AMENDMENT DRAWING

AMENDMENT DRAWING

Project Title: VA PUGET SOUND HEALTH CARE SYSTEM UPGRADE SEATTLE ELECTRICAL DISTRIBUTION FROM 5kV TO 15kV

Drawing Number: 028 89-EP101R

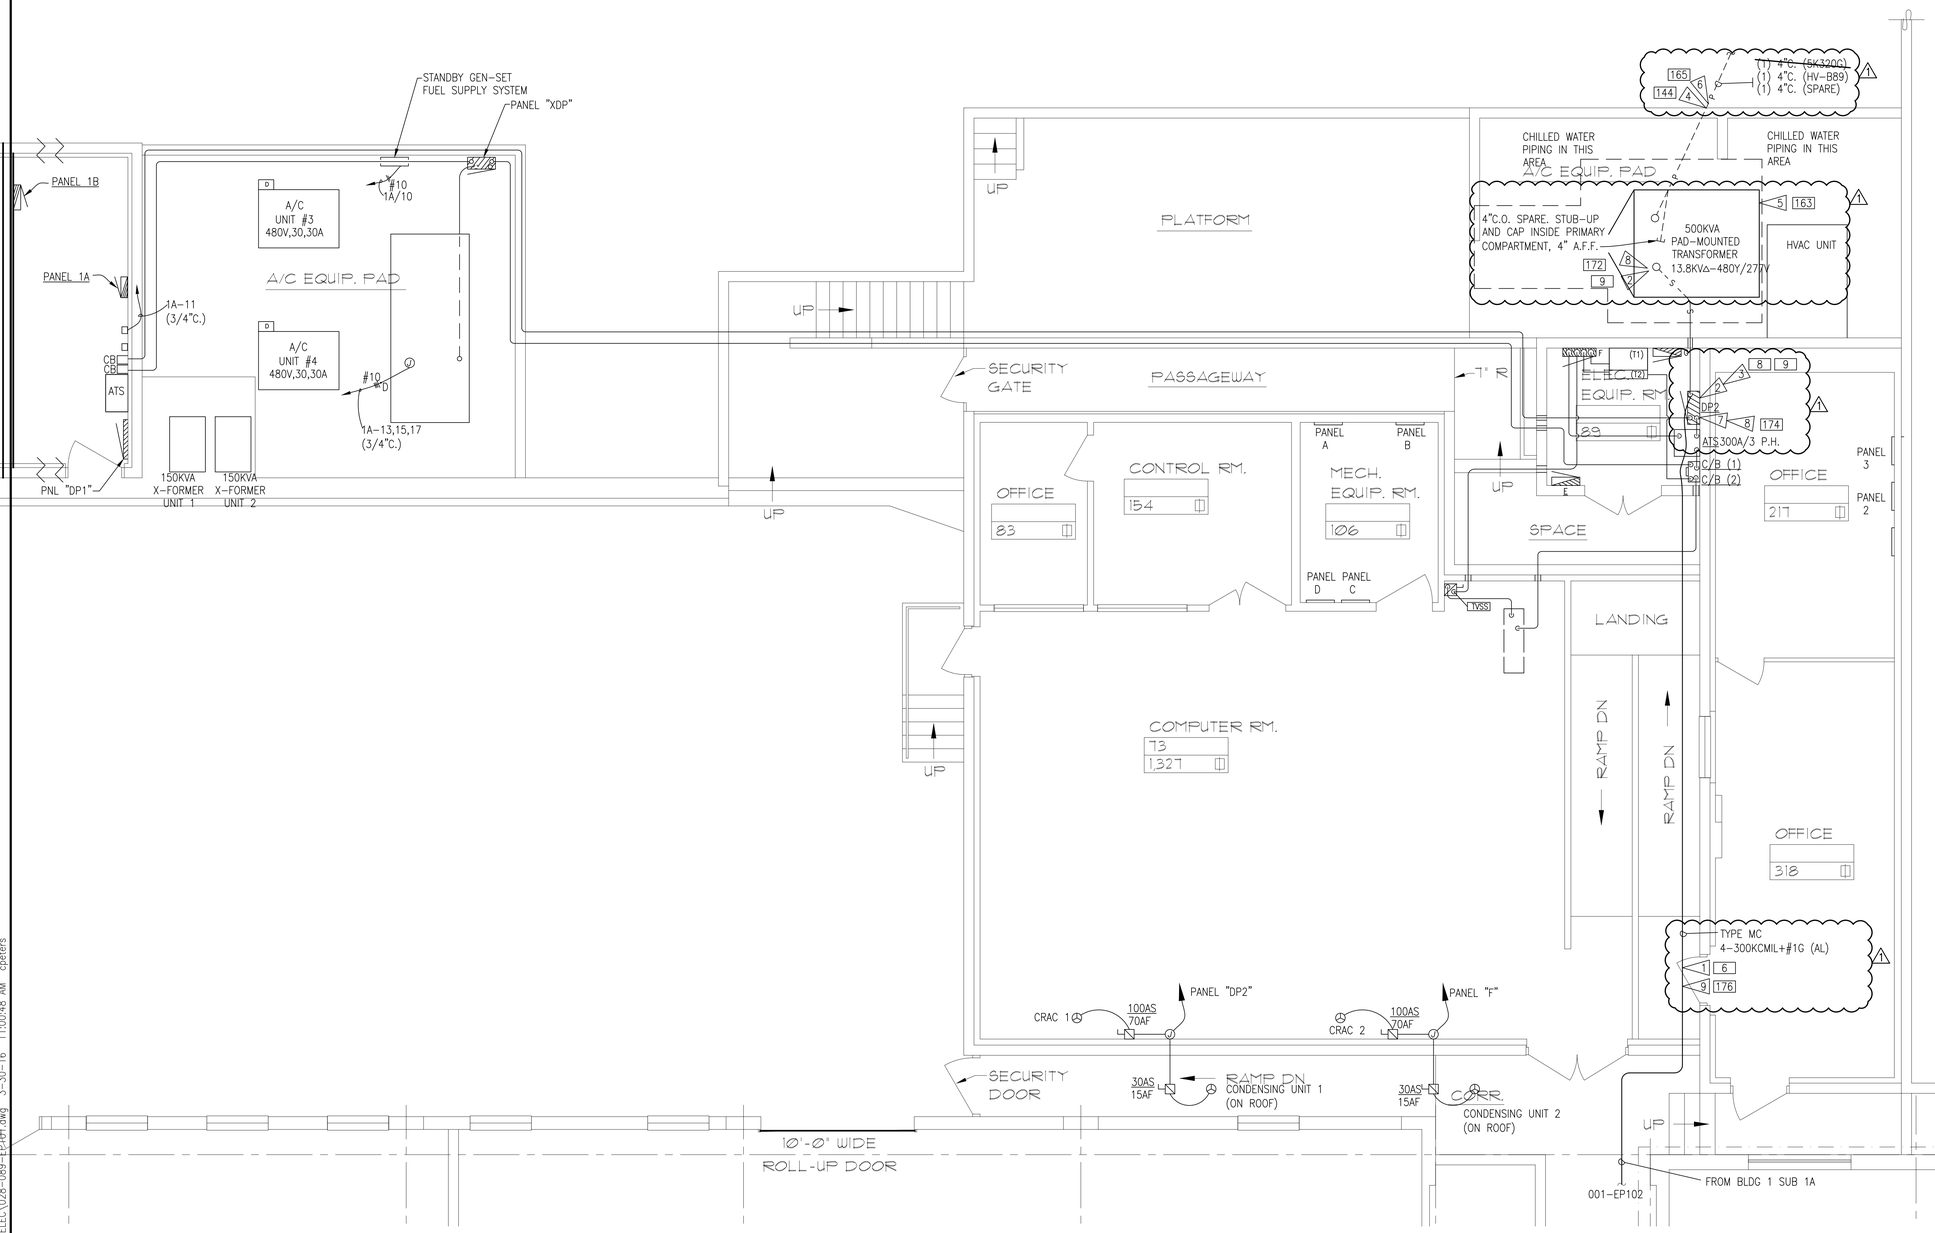
4 REMOVE 5KV FEEDER. SEE DWG 028 89-ES101.

5 REPLACE TRANSFORMER WITH 500KVA 13.8KV – 480Y/277V TRANSFORMER.

8 CONNECT SUPPLY FEEDER TO EQUIPMENT.

1 9 REMOVE TEMPORARY FEEDER BACK TO SUB 1A.

Drawing Number: 028 89-EP601R

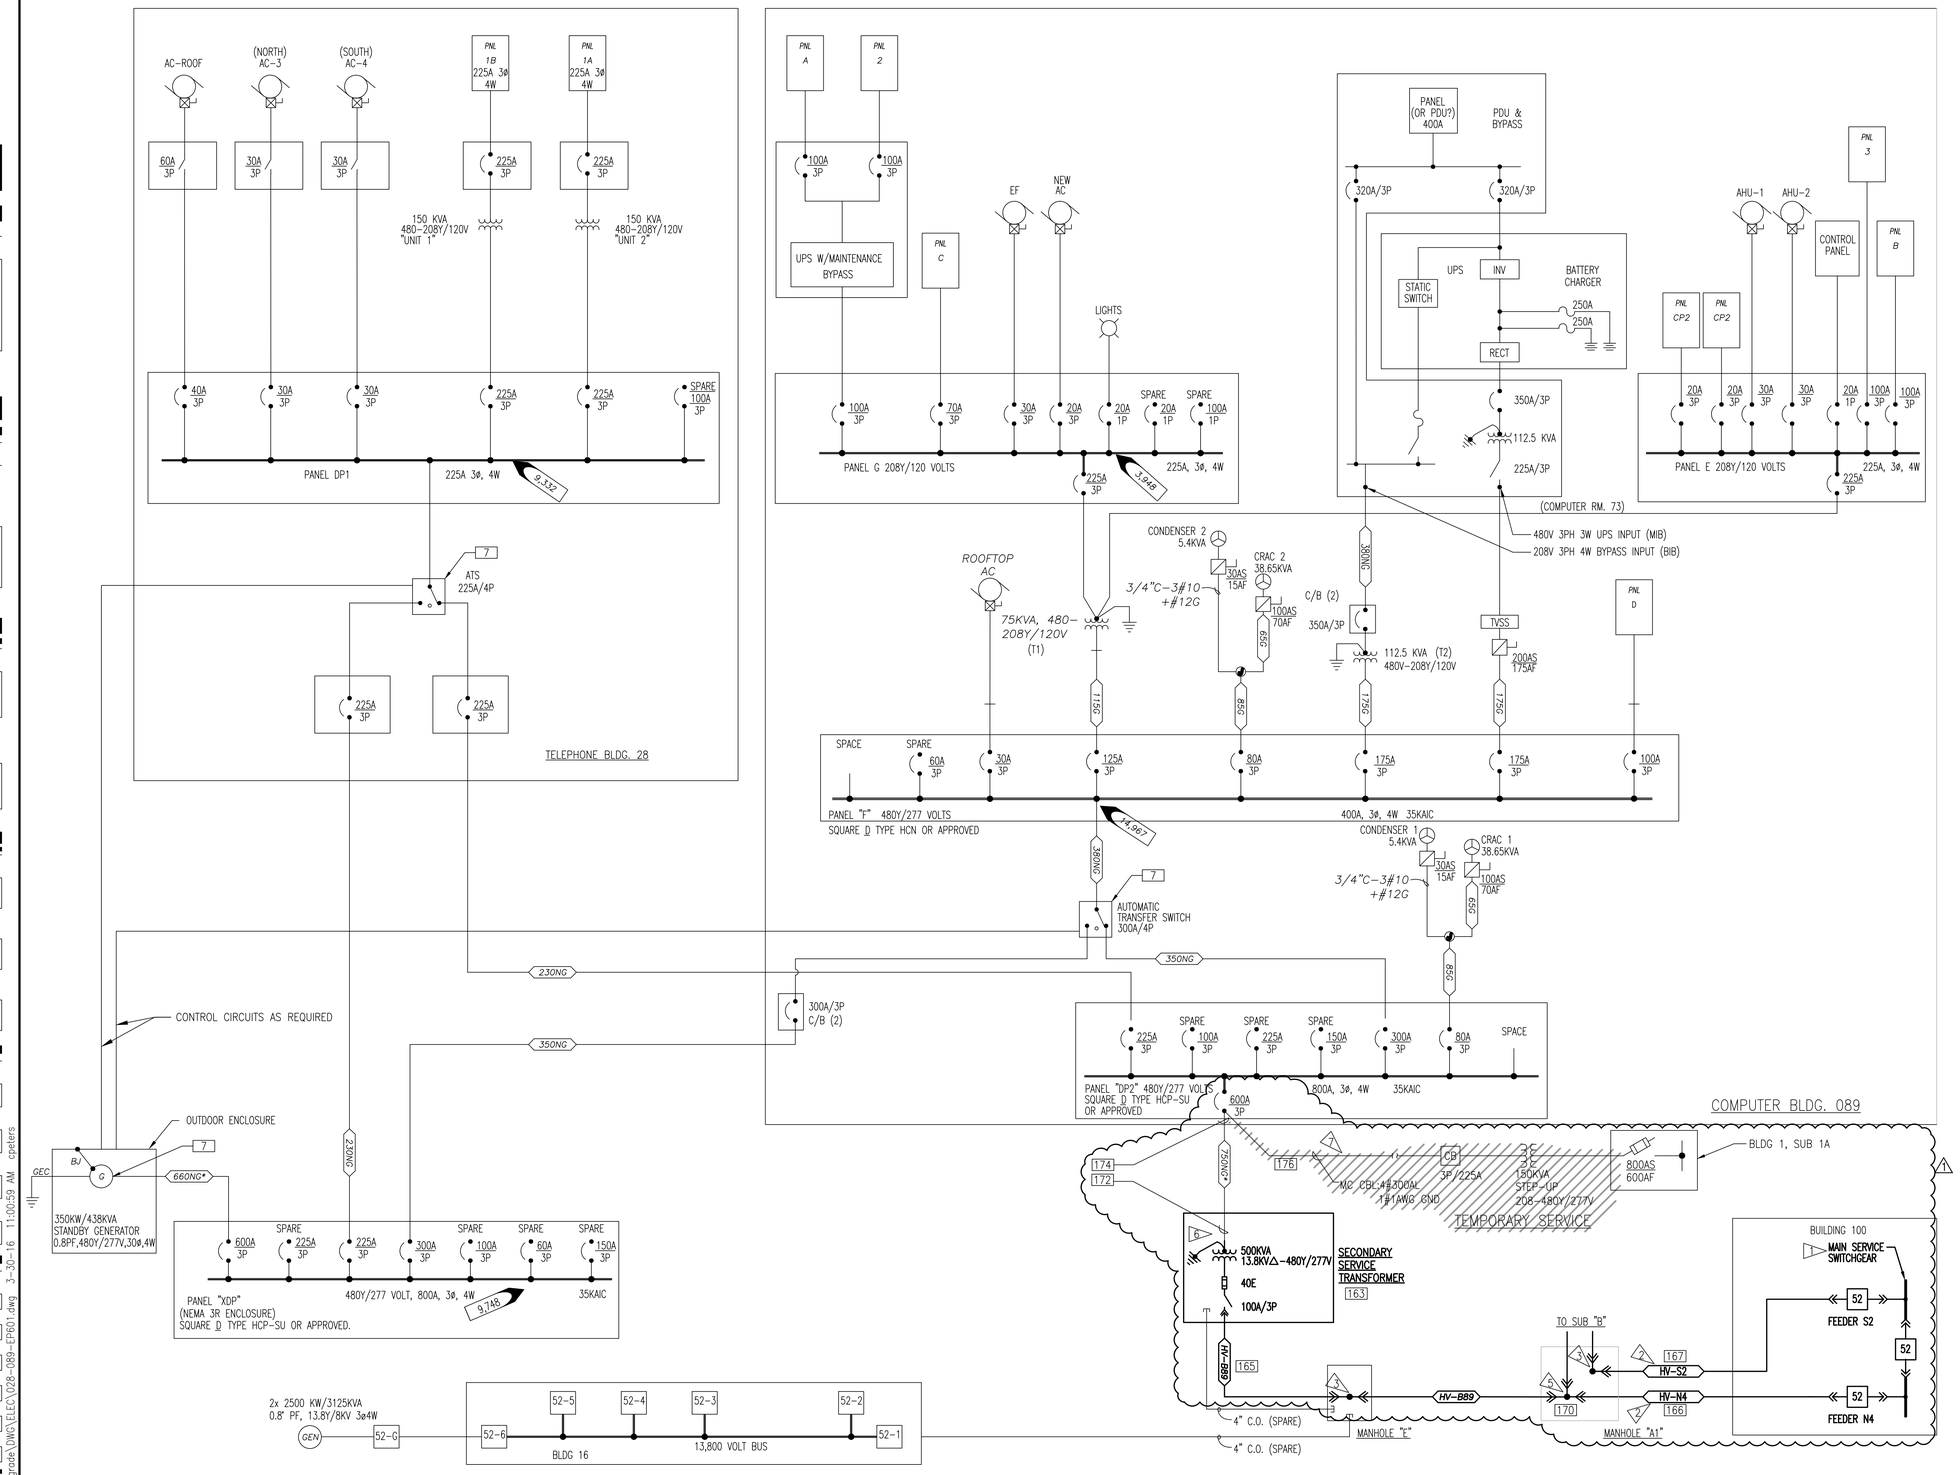
1. NEW MAIN SWITCHGEAR, SEE DWG 100-EP601.
2. NEW FEEDER TO SUB B, SEE DWG 100-EP601.
3. PROVIDE NON-LOAD BREAK 600A 2-WAY CONNECTION IN MANHOLE INCLUDING REQUIRED ACCESSORIES.
4. NEW 15KV FEEDER TO BLDG 28 AND 89.
5. PROVIDE NON-LOAD BREAK 600A 3-WAY CONNECTION IN MANHOLE INCLUDING REQUIRED ACCESSORIES.
6. PROVIDE NEW TRANSFORMER WITH FUSES AND ACCESSORIES AS SHOWN.
7. AFTER BUILDING 89 IS TRANSFERRED TO NEW PERMANENT SUPPLY, REMOVE TEMPORARY FEEDERS AND EQUIPMENT BACK TO BUILDING 1 SUB 1A.
